RE: OSDS Plan 6820 Koandah Gardens (McDaniel Prop. "Lot 9")

Mound/OSDS Revision Comments

RE: **McDaniel Property, proposed Lot 9 and Non-buildable Preservation Parcel 'C',
Percolation Certification Plan; comments**

EXHIBIT "A"

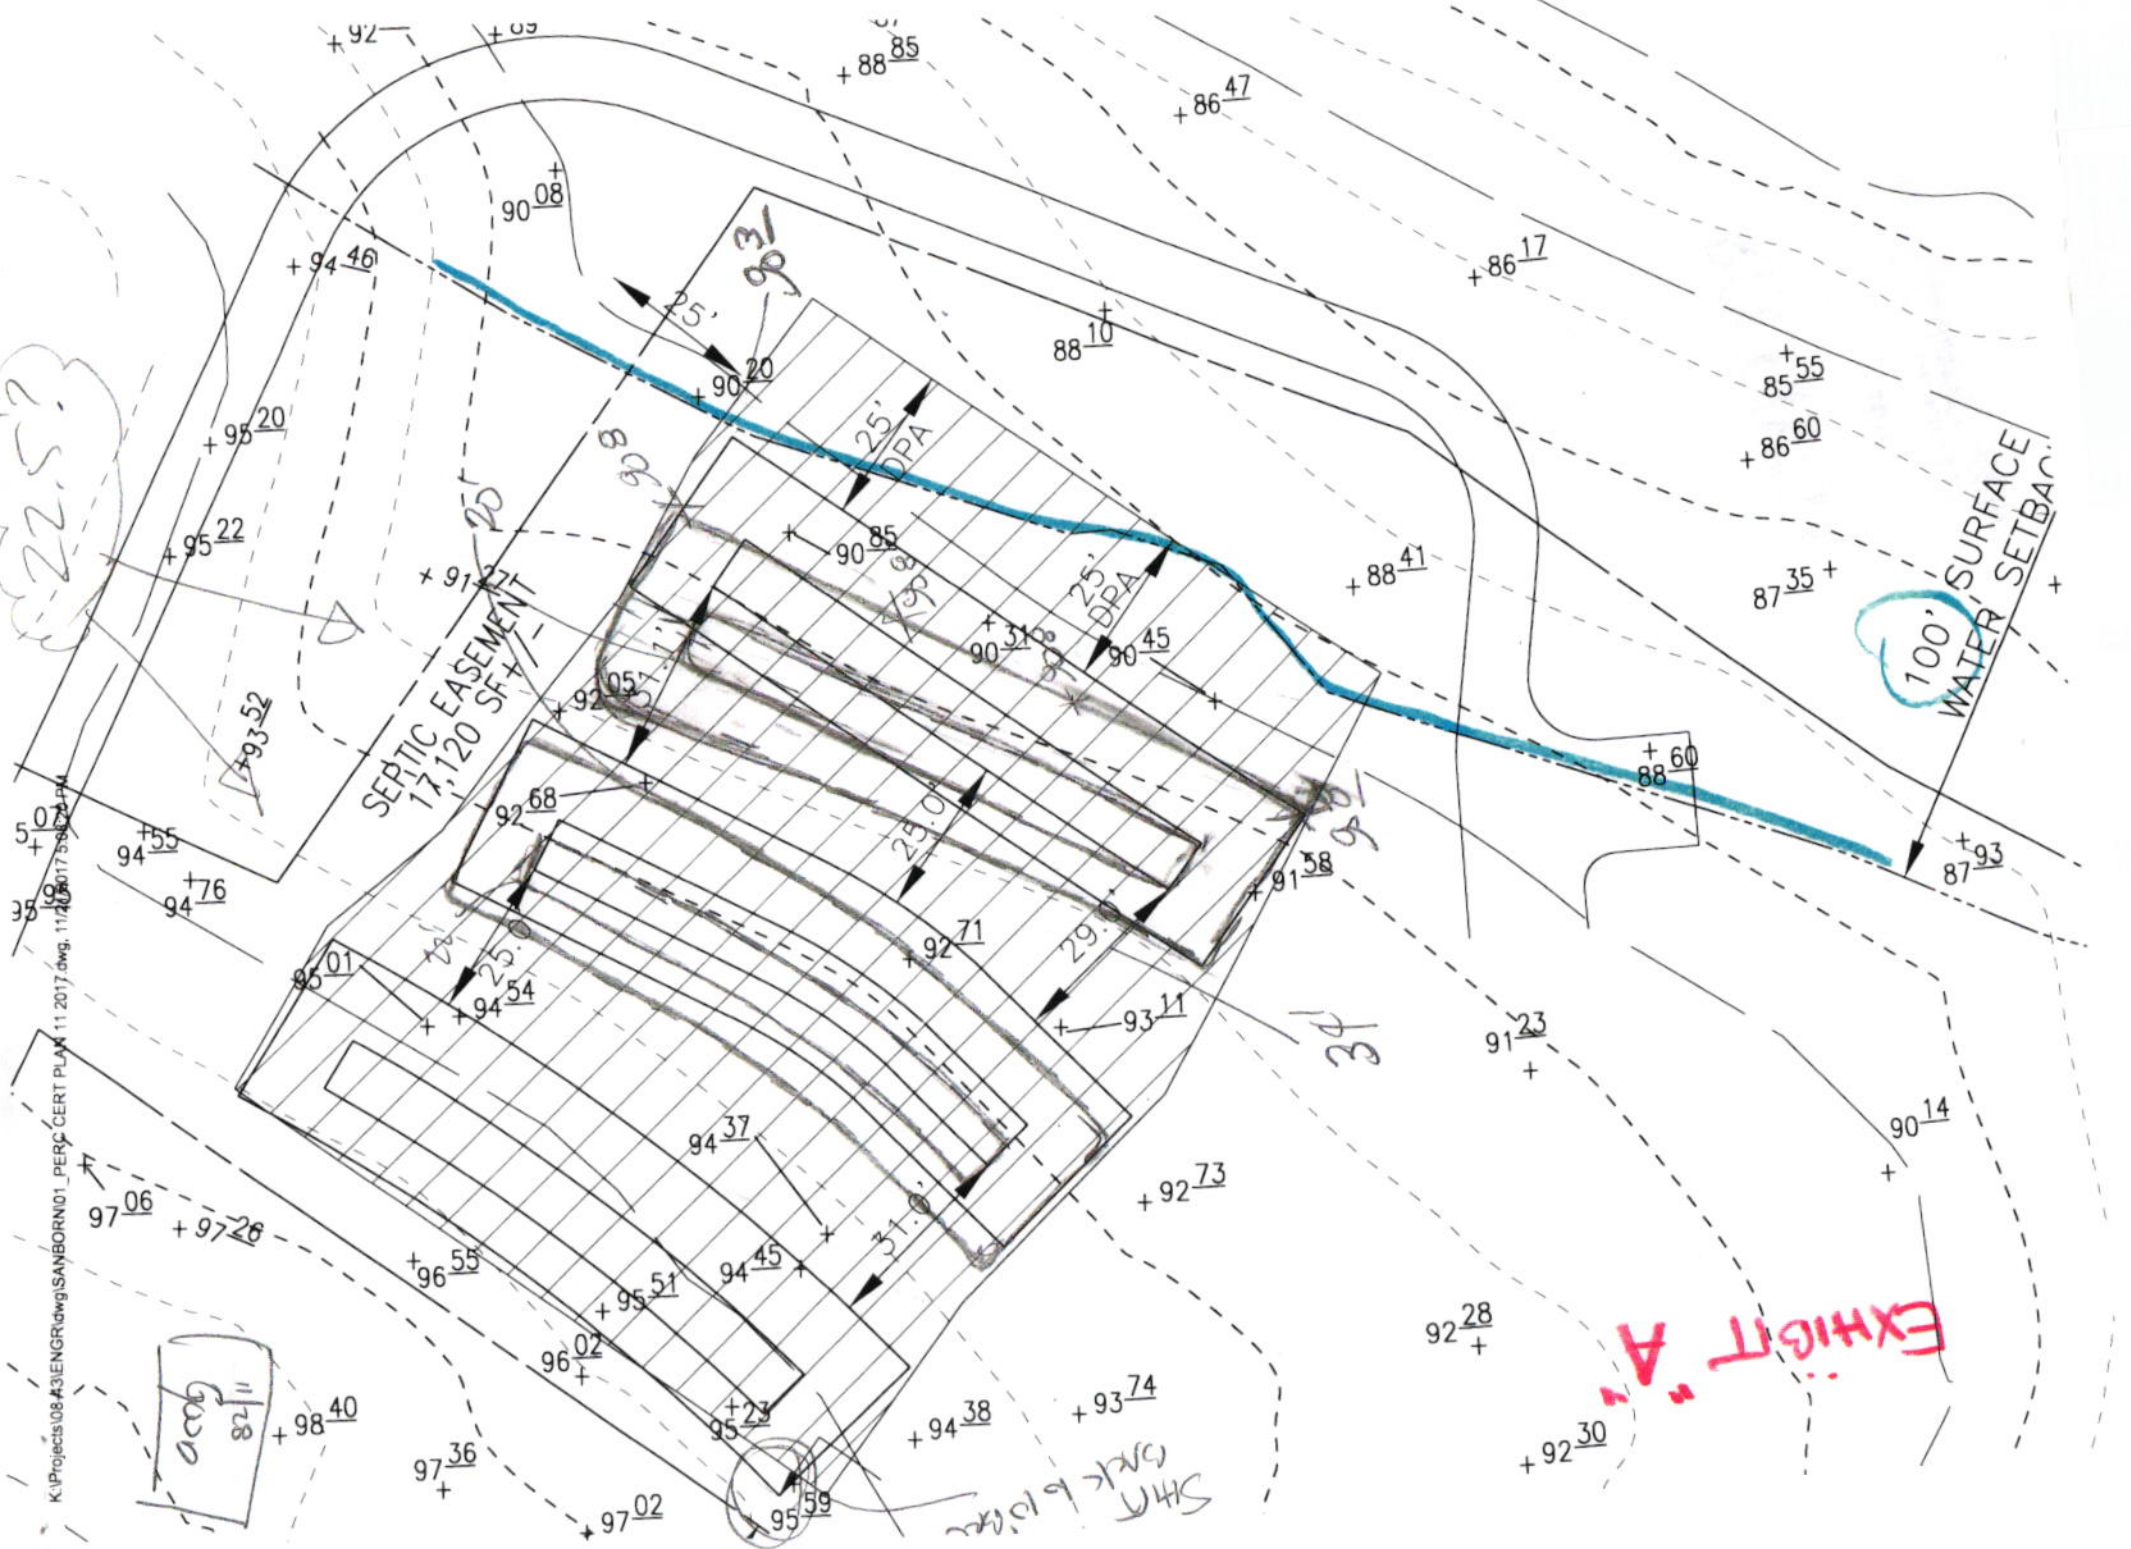
- Exhibit "A" from November 28, 2017 meeting is preferred layout+/- . See Attached.
- Exhibit "B" from November 28, 2017 meeting is a clean version of July 2017 plan. See Attached.

Stacked Mound Spacing

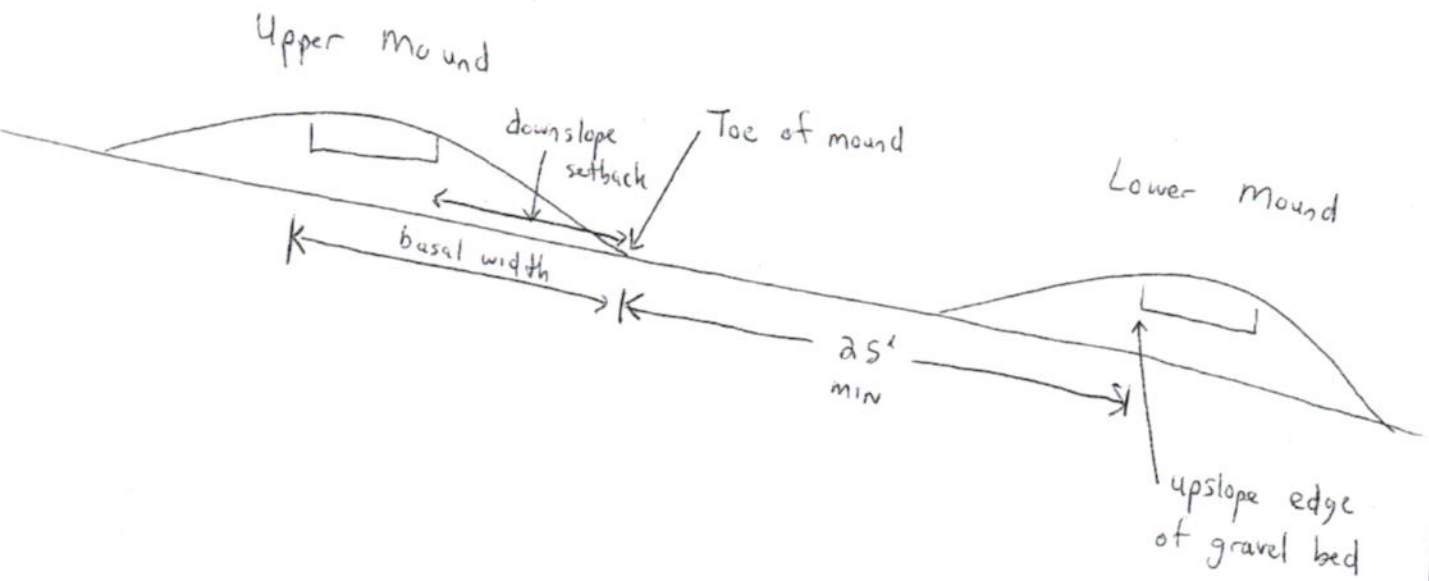
6. Comment noted. In accordance with the "Stacked Mound Spacing" sketch dated 5/ 2106 by Steve Krieg, the required 25 feet of separation has been met. This places the Sewage Disposal Area 10 feet from the southern property line at offsite Open Space 78 and approximately 8' from the 100' surface water setback line.
